NOTICE OF ADDENDUM
ADDENDUM NO. 2
City of Madison, Engineering Department

CONTRACT NO. 8981
METRO TRANSIT PHASE 3A – MAINTENANCE AND DRIVER FACILITY IMPROVEMENTS

This addendum is issued to modify, explain or correct the original Drawings, Specifications, or Contract Documents marked as *Metro Transit Phase 3A–Maintenance and Driver Facility Improvements, City of Madison, Contract #8981, as issued on April 8th, 2021* and is hereby made a part of the contract documents.

S-101D

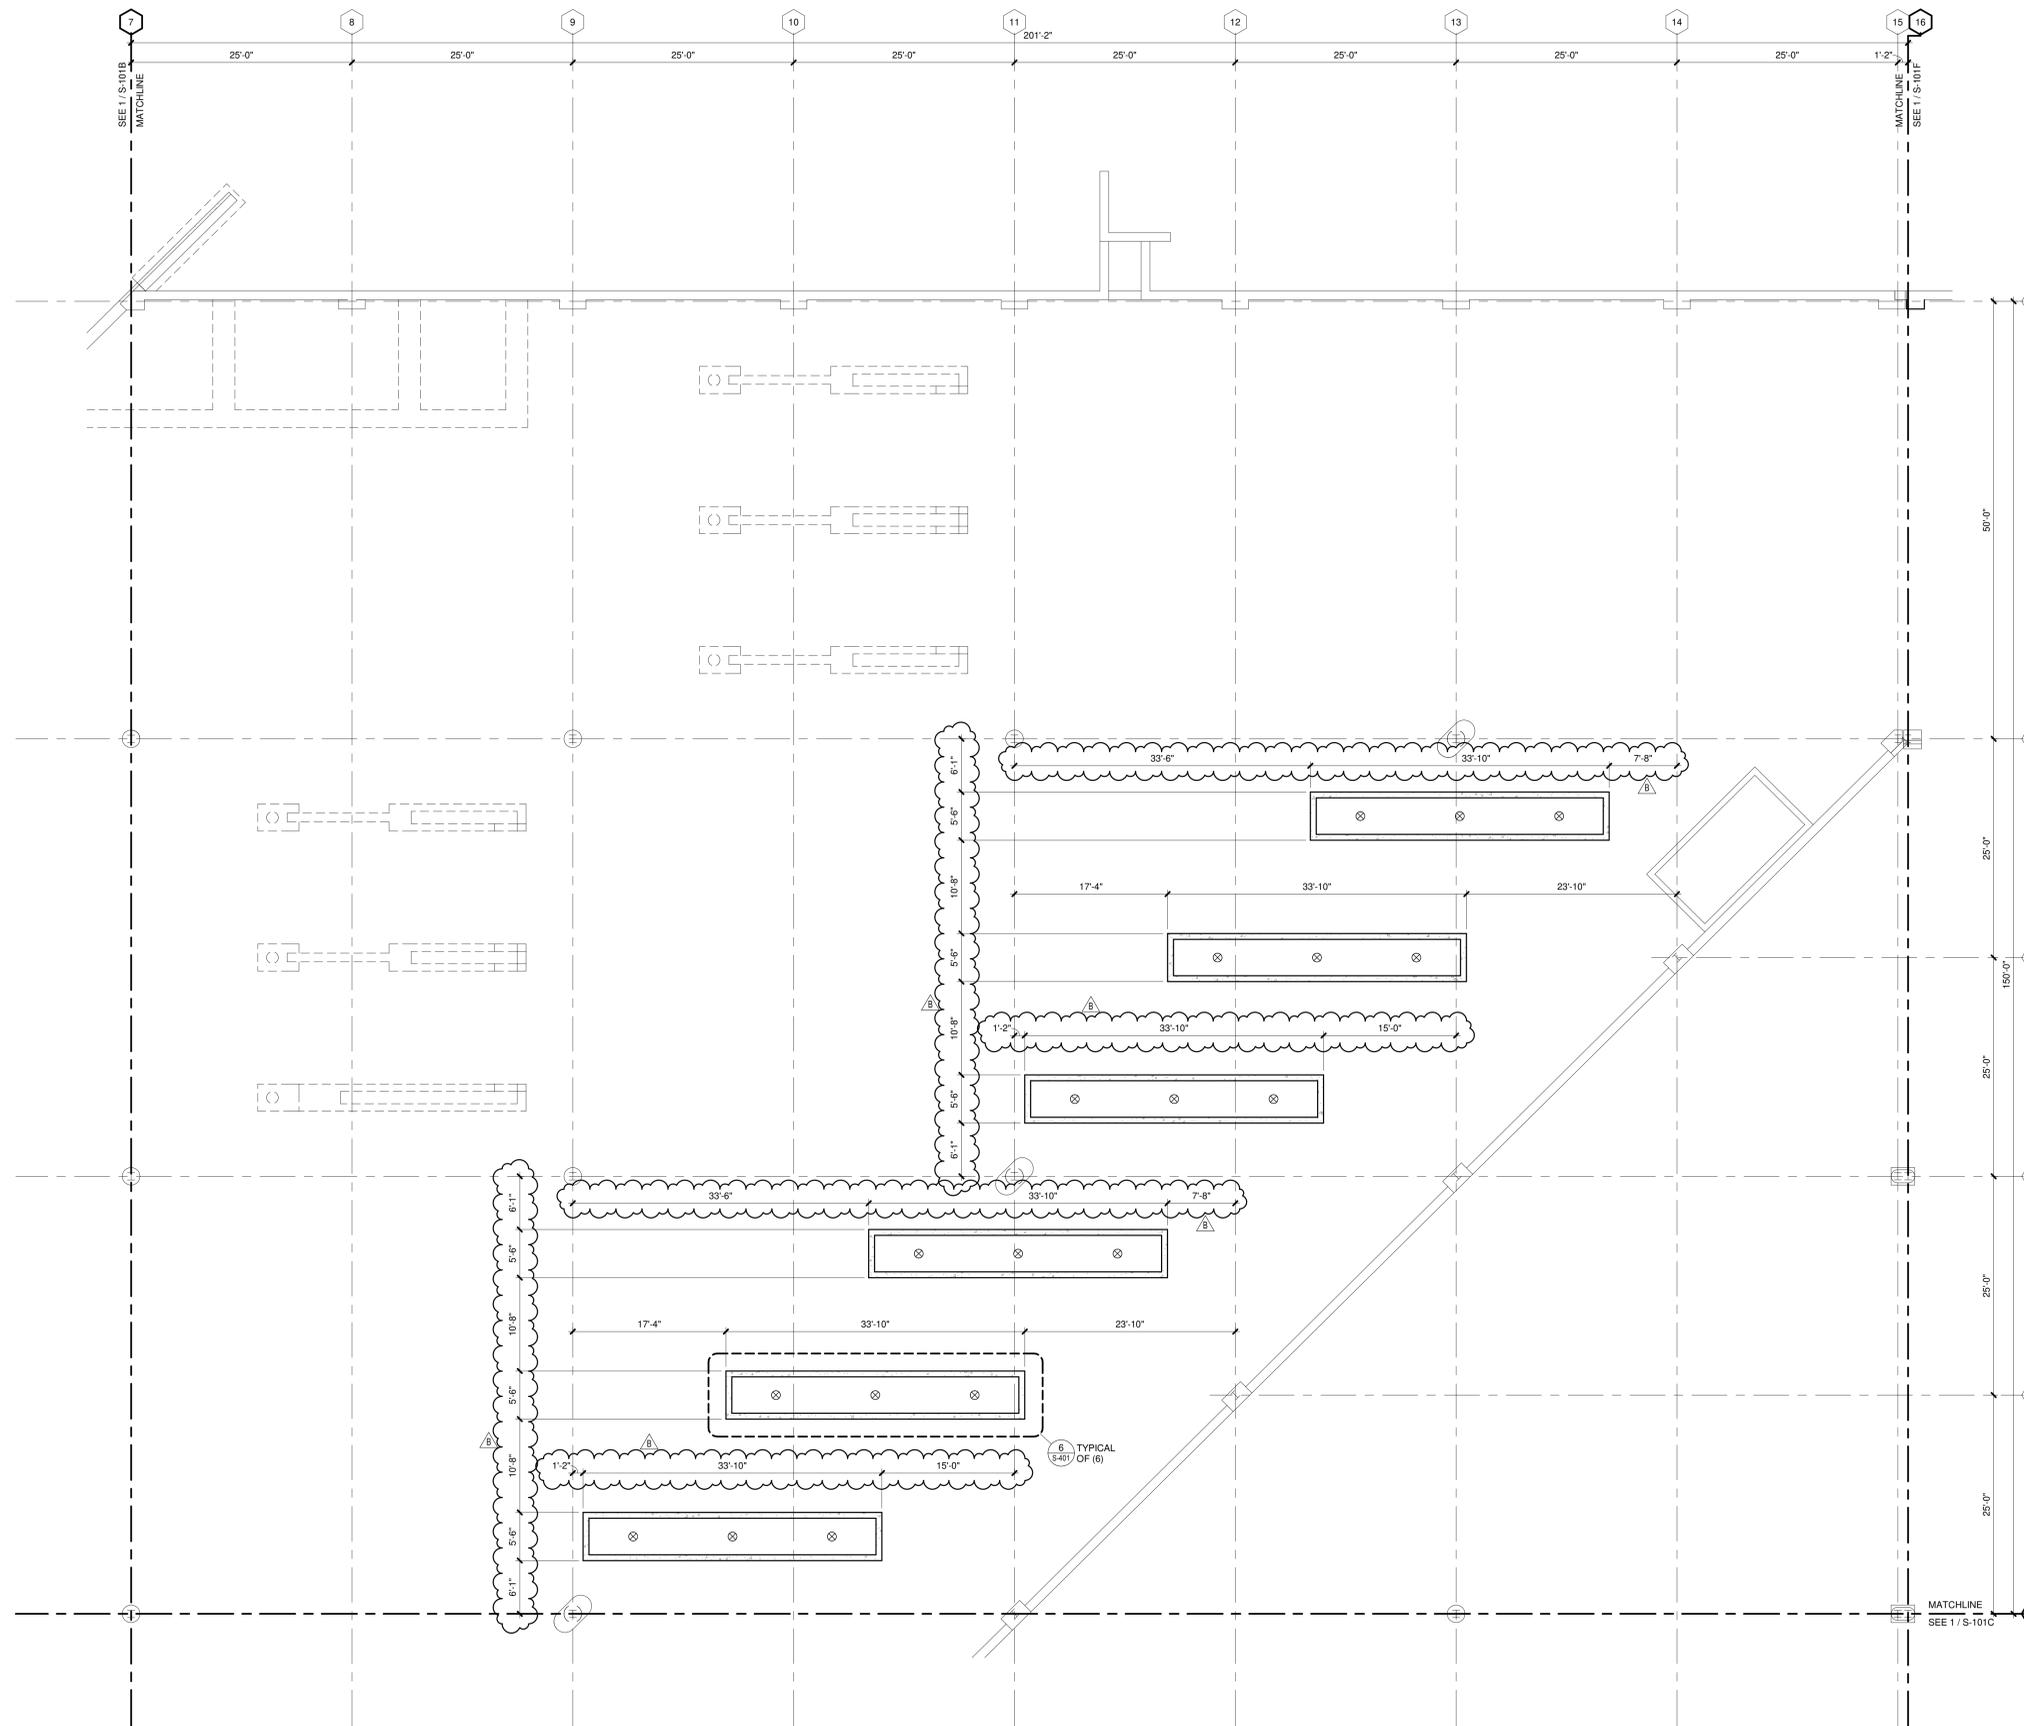
- vi. Drawing S-101C (attached); Added dimensions for pit foundations.
- vii. Drawing S-101D (attached); Added dimensions for pit foundations.
- viii. Drawing S-111A (attached); Paving added at end of truck dock.

S-142A

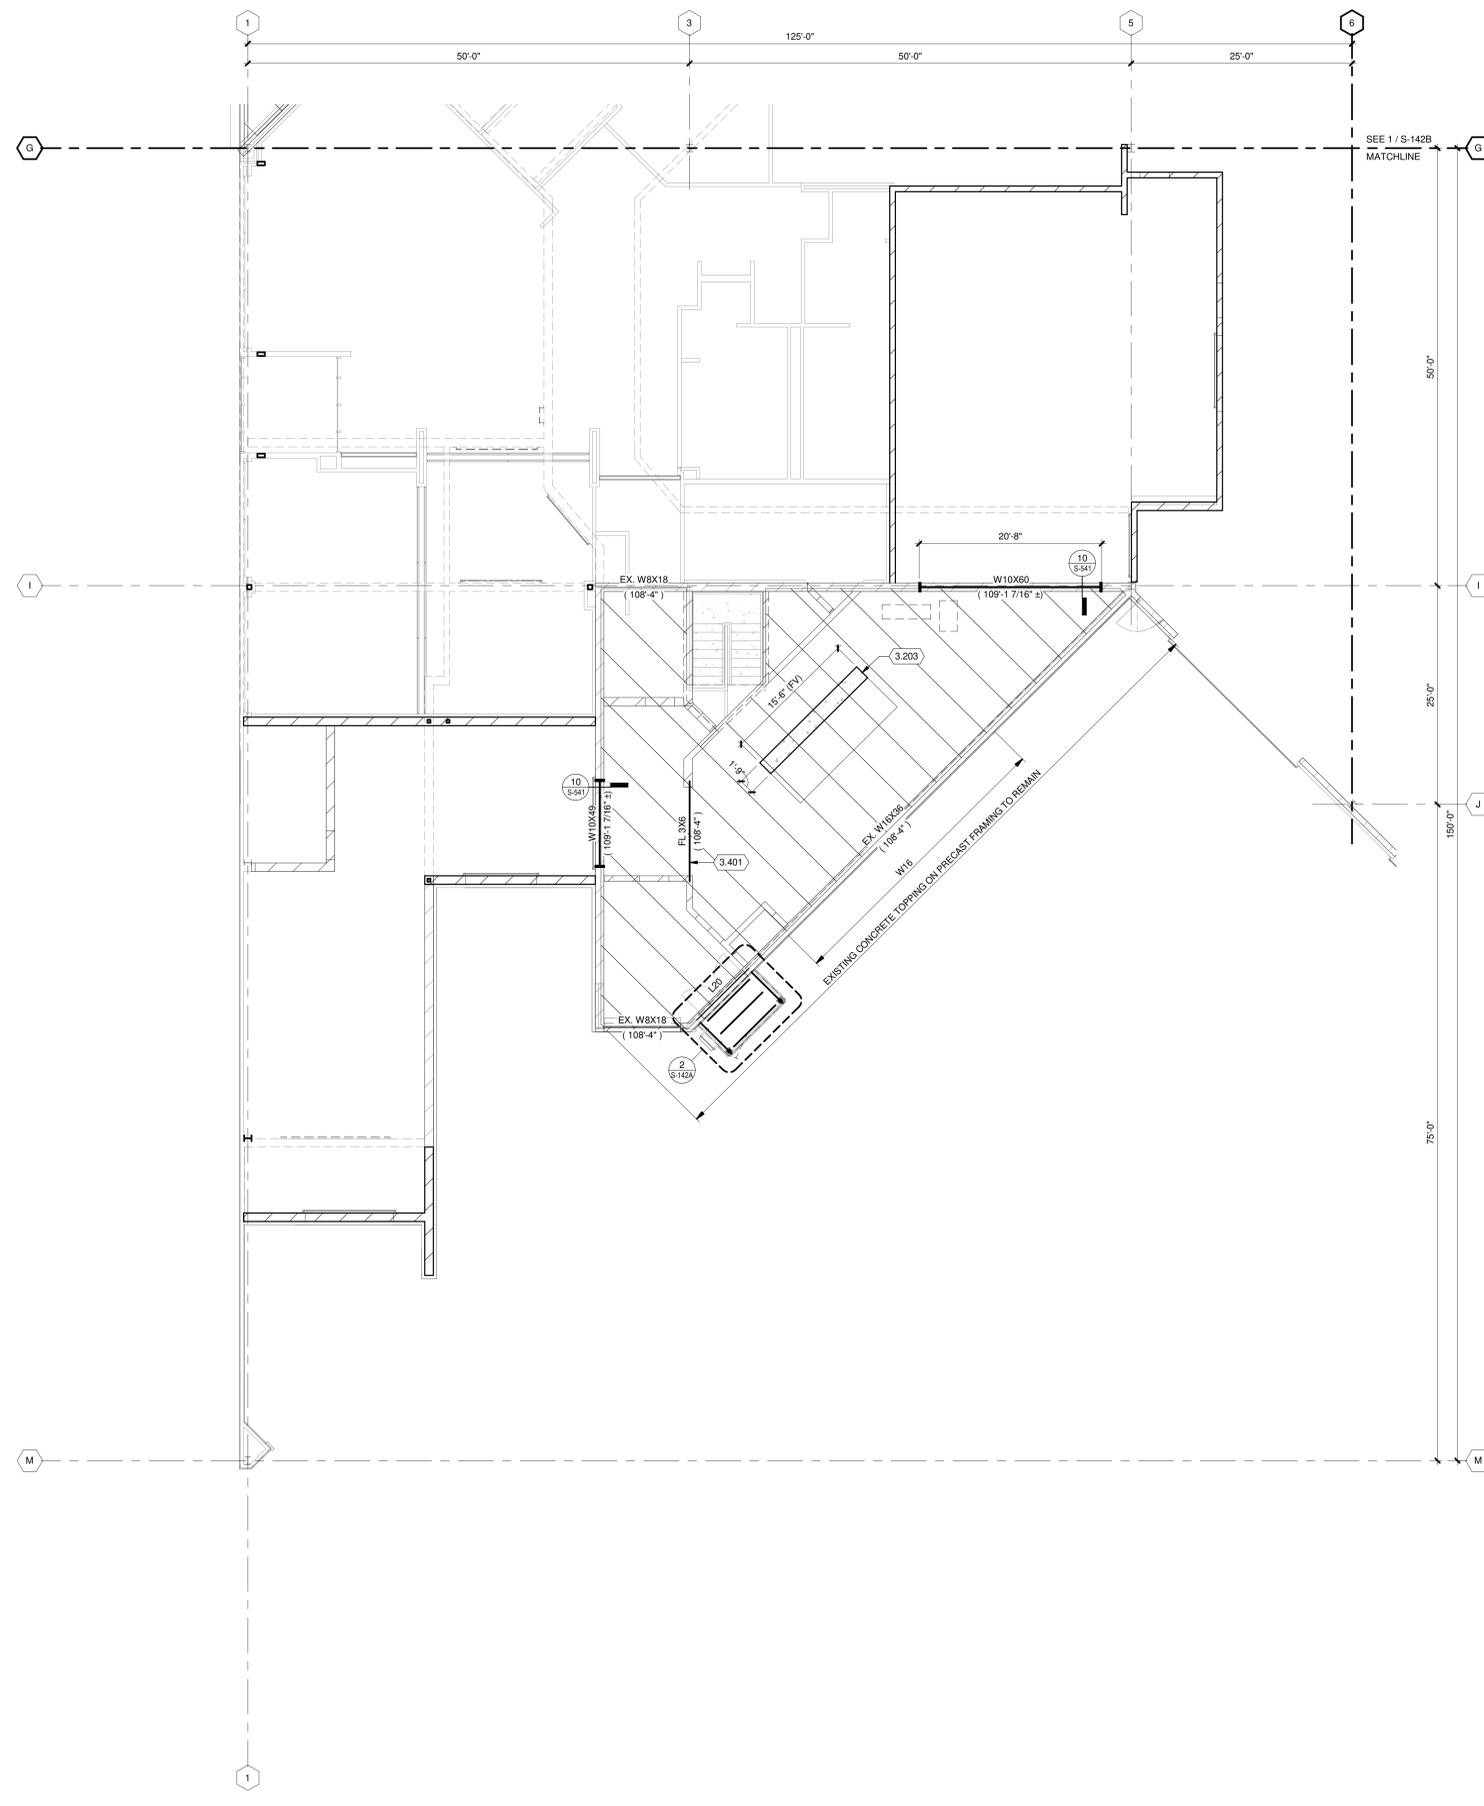
- ix. Drawing S-131A (attached);
 - Added referenced to spandrel connection 20/S-531.
 - Added spandrel in breakroom.
 - Adjusted wall in parts room.
- x. Drawing S-142A (attached); Added platform connections to existing.

14 PIER REINFORCEMENT NEW PIER AT EXISTING GRADE BEAM
3/4" = 1'-0"

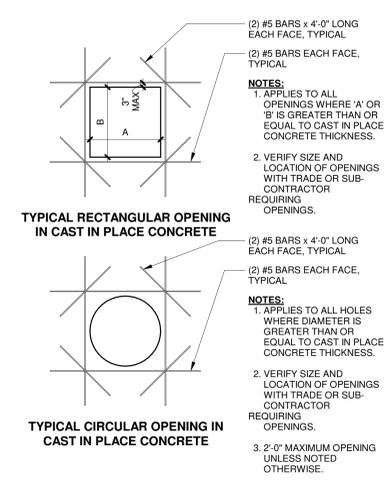
- xi. Drawing S-401 (attached); Removed extraneous detail reference.
- xii. Drawing S-441 (attached);
 - Details 1,2; Added detail reference.
 - Added detail 14/S-441.

23 PLATFORM WF BEAM CONNECTION AT MASONRY
1 1/2" = 1'-0"

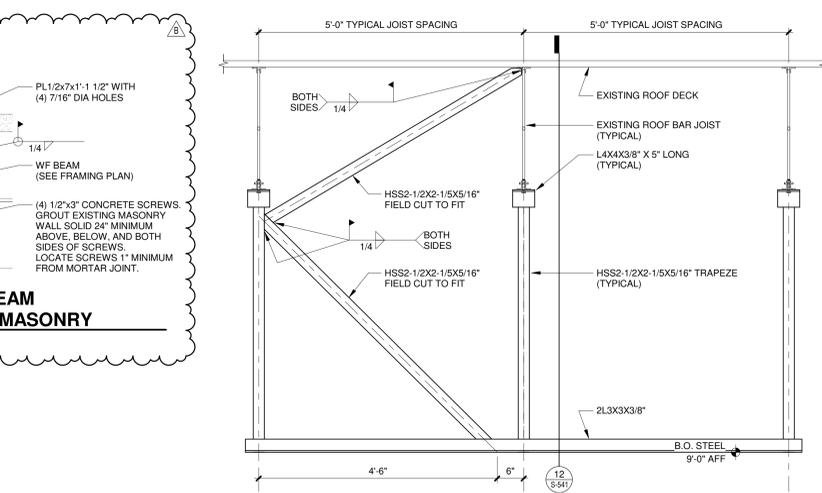
- Modified detail 18.
 - Changed detail name ‘B’ to 22.
 - Added details 19 and 23.
- xvi. Drawing S-551 (attached); Added detail 9.
